**CENTRAL ELECTRICITY REGULATORY COMMISSION**  
**New Delhi**

Central Electricity Regulatory Commission (Indian Electricity Grid Code) Regulations (5<sup>th</sup> Amendment), 2017

**Statement of Reasons**

### 13.1.2 NTPC has submitted following

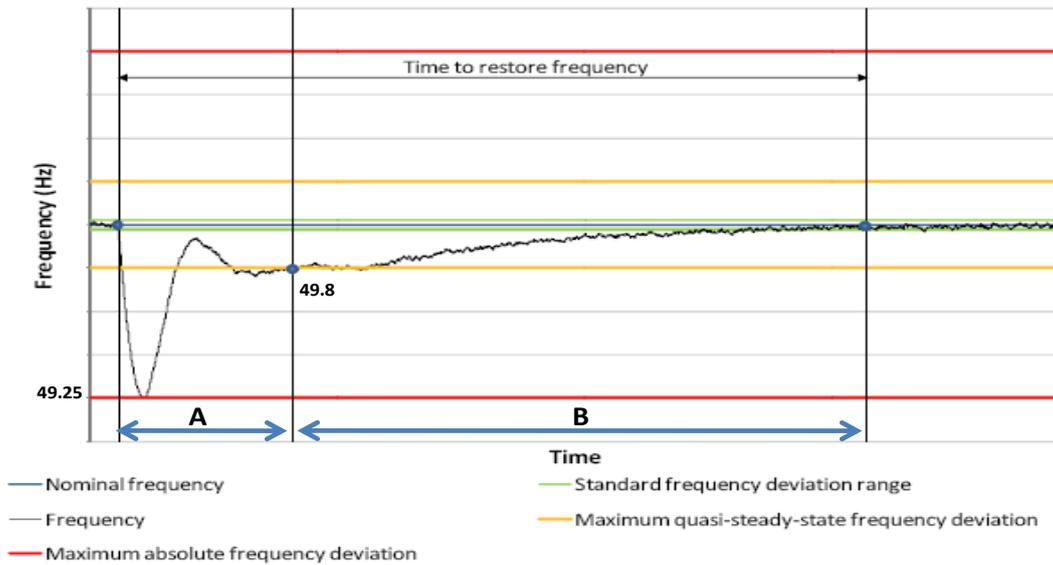
(a) With respect to Primary Reserve Requirement in India:

Primary control (governor control) is used for frequency stabilization after a large disturbance which operates in seconds (proportional control), the Secondary control restores the primary reserves and frequency to target frequency (50 Hz) and operates in minutes (Integral control) and the tertiary control restores secondary reserves and operates in tens of minutes. For keeping primary reserves, it is necessary to define "event" / "disturbance" and also the quasi steady

Parameter	Unit	Peak Load
Demand	MW	150,000
Generation	MW	150,000
"Disturbance" Generation outage, $\Delta P_G$	MW	4500
Post trip Generation, $P_G' (=P_G - \Delta P_G)$	MW	145,500
<b>Capacity of Machines on Governor control to deliver primary response.</b>	<b>MW</b>	<b>40,000</b>
<b>D (Load Damping)**</b>	<b>MW/Hz</b>	<b>6,000</b>
<b>1/R (Governing)***</b>	<b>MW/Hz</b>	<b>16,000</b>
<b>AFRC, <math>\beta = (D + 1/R)</math></b>	<b>MW/Hz</b>	<b>22,000</b>
<b><math>\Delta f = \Delta P_G \div \beta</math></b>	<b>Hz</b>	<b>-0.20</b>
<b><math>f = f_N + \Delta f</math></b>	<b>Hz</b>	<b>49.80</b>

- (i) So, putting RGMO / FGMO with MI in almost all machines as proposed in the IEGC, even in the Gas Turbines, is a luxury attracting in-fructuous/ avoidable expenditure for making the old systems RGMO compliant.
- (ii) Even withholding cheaper power of Pit head stations like Sipat, Singrauli, Korba etc. for the purpose of primary response is also against the theory of economic despatch.
- (iii) Primary Reserve margin may be kept in those machines whose variable cost is moderately high and operating at part load. System operator should carry out such study and earmark those 40,000 MW plus machines which must be operated on Governor control

13.2.3 NTPC has submitted that keeping primary reserves in stations with aggregate installed capacity of 40,000 MW would be sufficient to contain the frequency to 49.80 Hz in case of generation loss of 4500 MW. With the assumptions of 5% droop i.e. primary response of 40% per Hz and load dampening of 4% per Hz, the load dampening would be to the tune of 1200 MW for 0.20 Hz frequency fall (with load being met to the tune of 1,50,000MW) and primary response would be to the tune of 3200 MW ( $40,000 \times 0.40 \times 0.20$ ). In this regard, we have analyzed that the generation increase works out to 8% of the participating installed capacity putting more strain on participating stations in terms of fluctuations in operating parameters which may eventually lead to unit tripping or damage of costlier equipment. On the contrary, again consider the example of grid operating with installed capacity of 1,50,000 MW with the safe

assumption that 75,000 MW capacity would be providing primary response with 5% droop limited to 5% of generation level. Now in such case, going by the provision of IEGC, for generation loss of 4500 MW, primary response would be to the tune of 3750 MW (5% of 75,000 MW) and difference would come through load dampening of 750 MW settling the new frequency at 49.875 MW i.e very close to the operating frequency band of 49.90 Hz to 50.05 Hz. In case, most of the generators provide primary response frequency would get restored very close to the 50 Hz. As such, considering the same, the primary response of 5% is being demanded from all the stations notwithstanding the cost repercussion as mentioned by NTPC. Further, regarding cost repercussion as mentioned by NTPC, it is pointed out that in percentage terms, the cost is not substantial for large Indian Grid. As such, this cost shall be borne by the beneficiaries for the purpose of grid security which ultimately is in the interest of the consumers as well as the nation at large. Further, with full RE penetration of solar and wind, only the thermal generating station having low energy charges would be in operation. As such exempting them from primary response would effectively mean that grid has no primary response.
